# MetroLink - Module 1

1. Tunnelling, Excavation Related Issues (Groundborne Noise & Vibration, Hydrogeological and soils impacts, settlement, property damage)
2. Airborne Noise & Vibration

## Witness Statement by Paul Quigley on Behalf of Charlemont & Dartmouth Community Group in relation to Soils and Hydrogeology

*Figure 1 Extract from A5.18 showing a rectangular footprint of Charlemont Station*

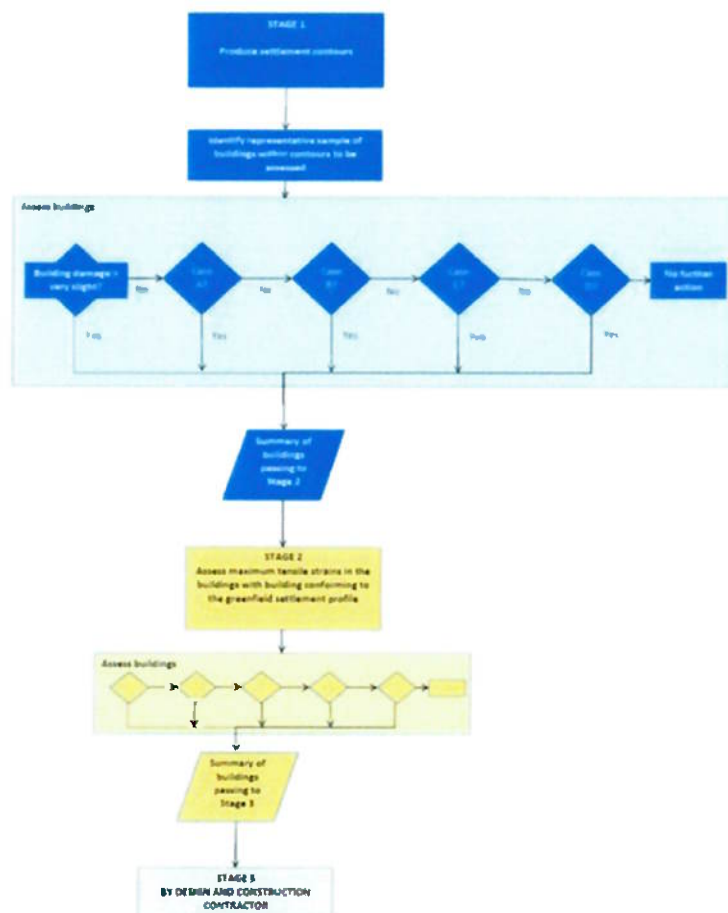
There are some concerning drawing conflict and quality issues associated with the Building Damage Assessment report. For example, the outline of the basement construction for Charlemont station has been simplified as a rectangle in ML1-JAI-EIA-ROUT\_XX-DR-Y-21150, whereas the extent of the retaining wall shown on the plan drawing ML1-JAI-SRD-ROUT\_XX-DR-Y-0209 and cross section drawing ML1-JAI-SRD-ROUT\_XX-DR-Y-02097 appears more realistic. The impact of the ground movement contours along Dartmouth Square West could significantly change the damage impact rating.

*Figure 4 Extract from 'Rivers of Dublin'<sup>3</sup> showing buried river systems in the vicinity of Charlemont Station*

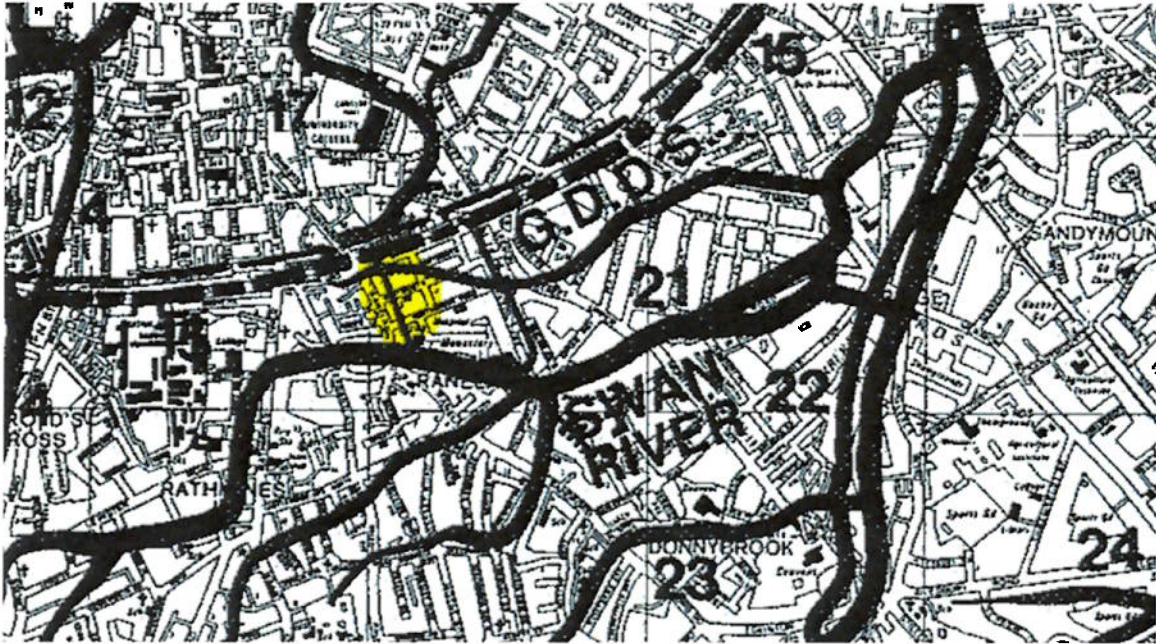
Chapter 18 of the EIAR describes some of the buried and hidden watercourses in the vicinity of the proposed Charlemont station. The source of the information is from Sweeney (1991) and an extract is shown on Figure 4. However, Chapter 19 does not address the potential impact of the station box interrupting any preferential flow paths within the buried watercourse, nor does the Building Damage Assessment associate the potential locations of loose deposits as a risk factor.
